REF. NO.: 91A/1486 CERTIFICATE NO.: 16  
 PROPOSAL: Dwelling + garage 10/9  
 LOCATION: Road of 20 Newtown Park, Tallaght  
 APPLICANT: A. Birdall

Register Reference : 91A/1486

Development : House on site to rear

Location : 20 Newtown Park, Tallaght

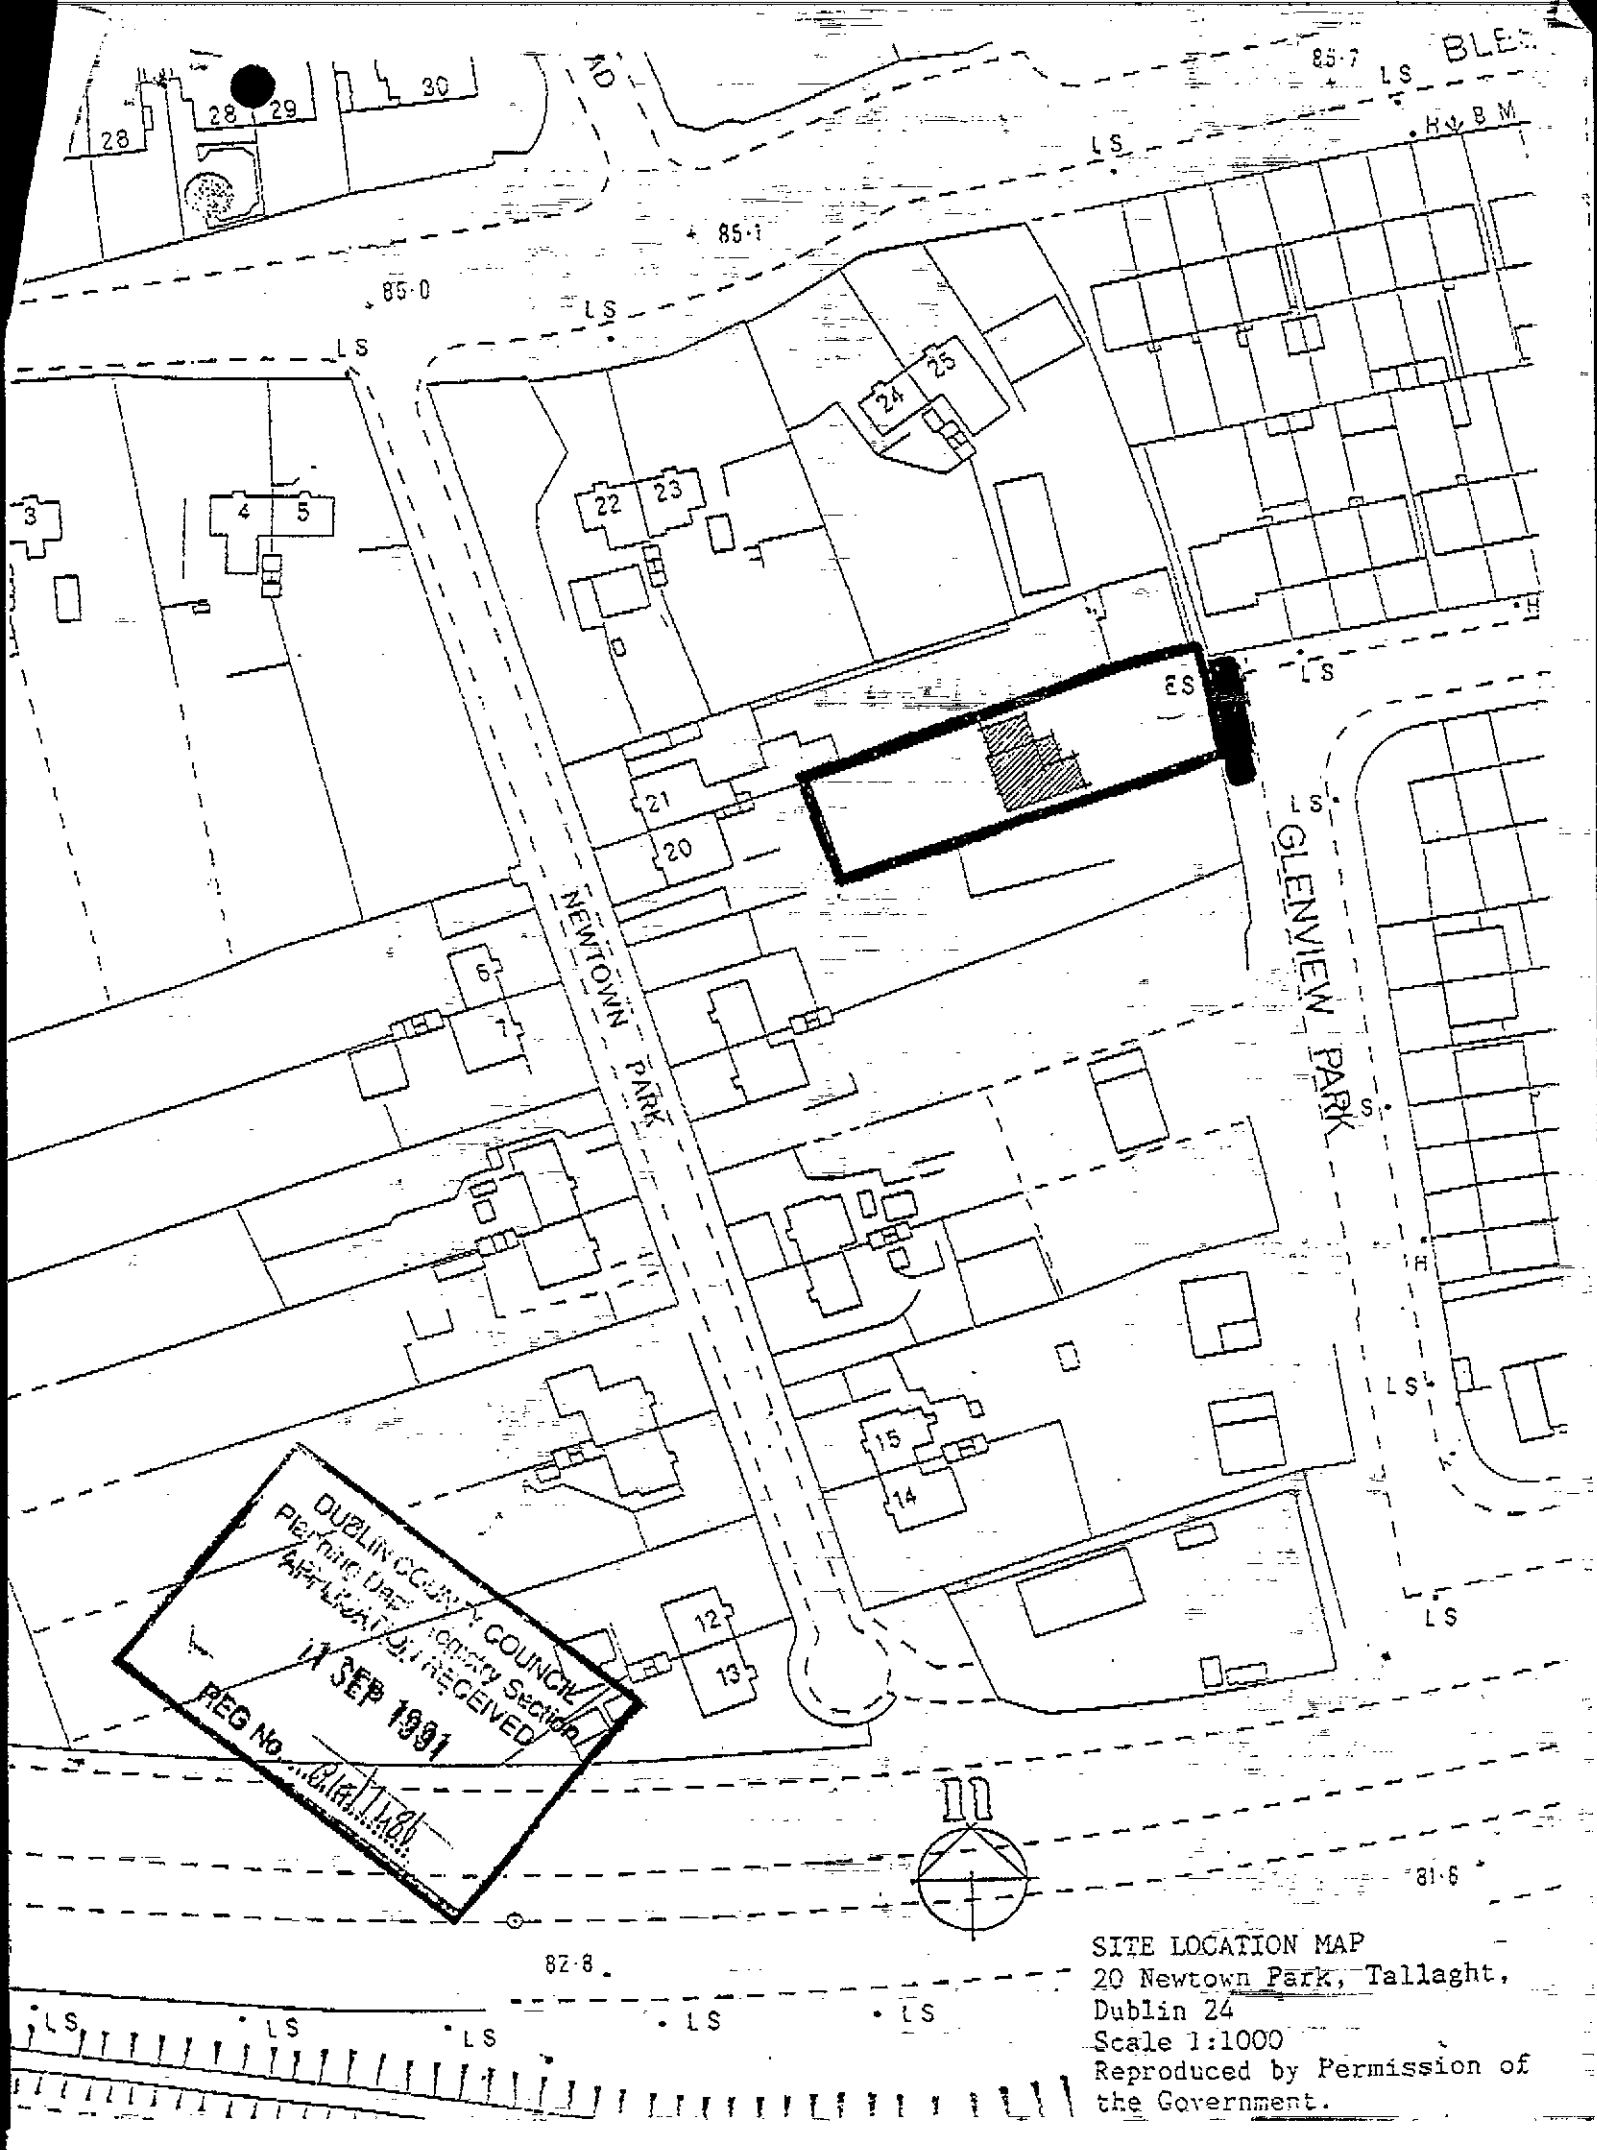
I refer to above Planning Application submitted by Mr. Andrew Birchall to build a 2 storey dwelling house and garage on site shown outlined black on attached map.

The position is that access to the property would appear to be across Corporation property shown coloured green on attached map..

I wish to inform you that no application has been received or permission granted to cross our land.

DRAWING NO: 91189.20/B

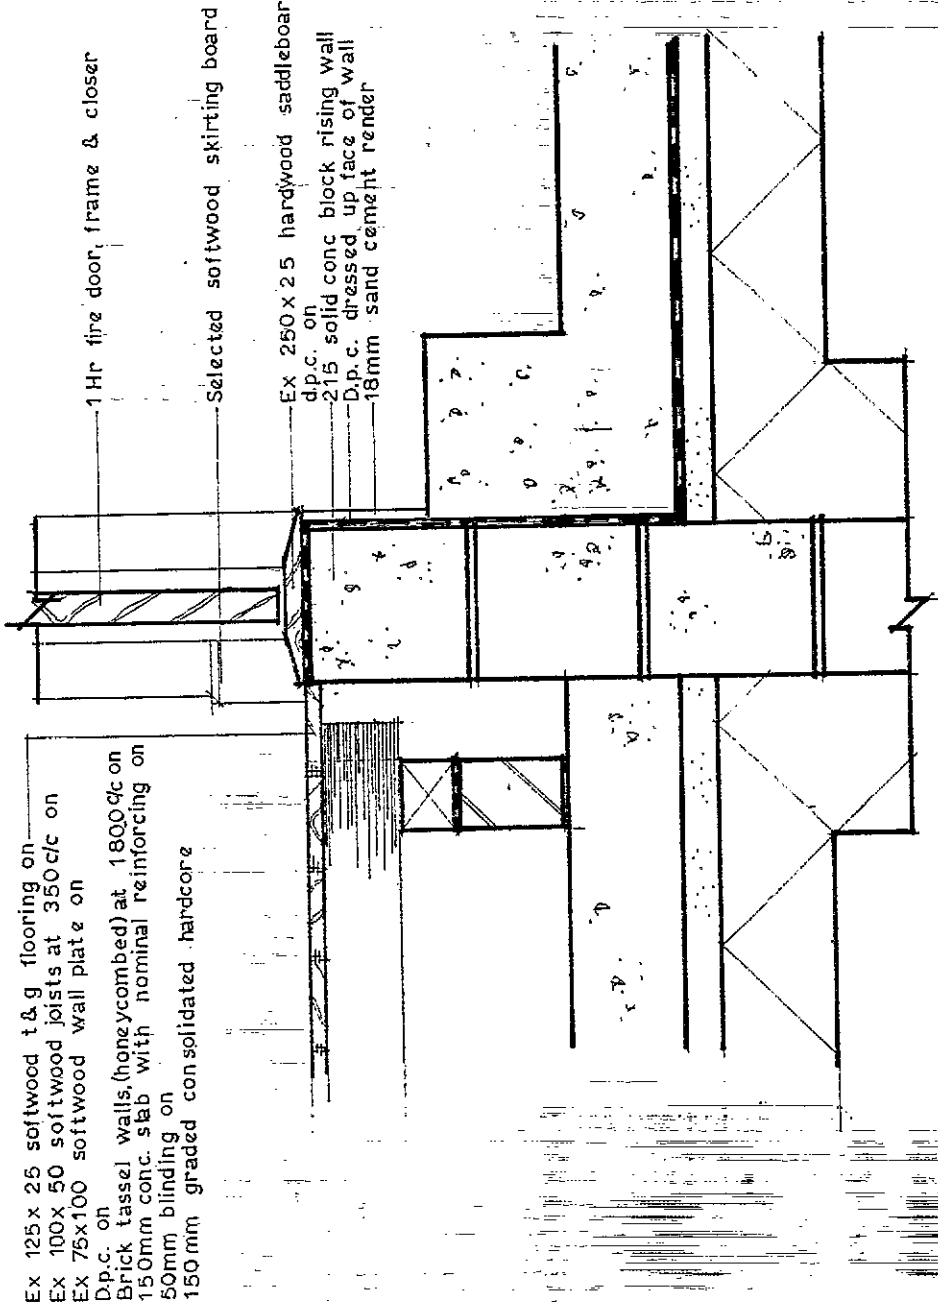
2. Applicant is requested to indicate accurately the line of the 450 m.m. foul sewer which passes the rear of the property and to indicate the distance of that sewer from the structure. In this regard it should be noted that a distance of 5 metres minimum should be maintained from a public sewer.

Sanitary Services Department request additional information regarding the exact line of the 450 m.m. sewer which passes at the rear of the property, and the distance of the sewer from the structure.

The line of the main sewer is shown at a distance of 11 metres from the proposed dwelling.

1. Revised Outline Specification
2. Location Map, Drawing No: 91189/20A, showing accurately the location of the existing County Council foul sewer at the rear of the property.
3. Drawing no. 91189/21, showing revised detailed drainage layout.
4. Please refer to the above drawing for details and specification in compliance with Building Bye-Laws.
5. Details of windows have been revised to comply with Building Bye-Law no. 76 (see drawing no. 91189/10).
6. Details of "Cloaks" drainage and ventilation, drawing no's. 91189/10 & 11 have been revised to comply with requirements.
7. All roof members to comply with SR11, a copy of which has been incorporated into the outline specification.
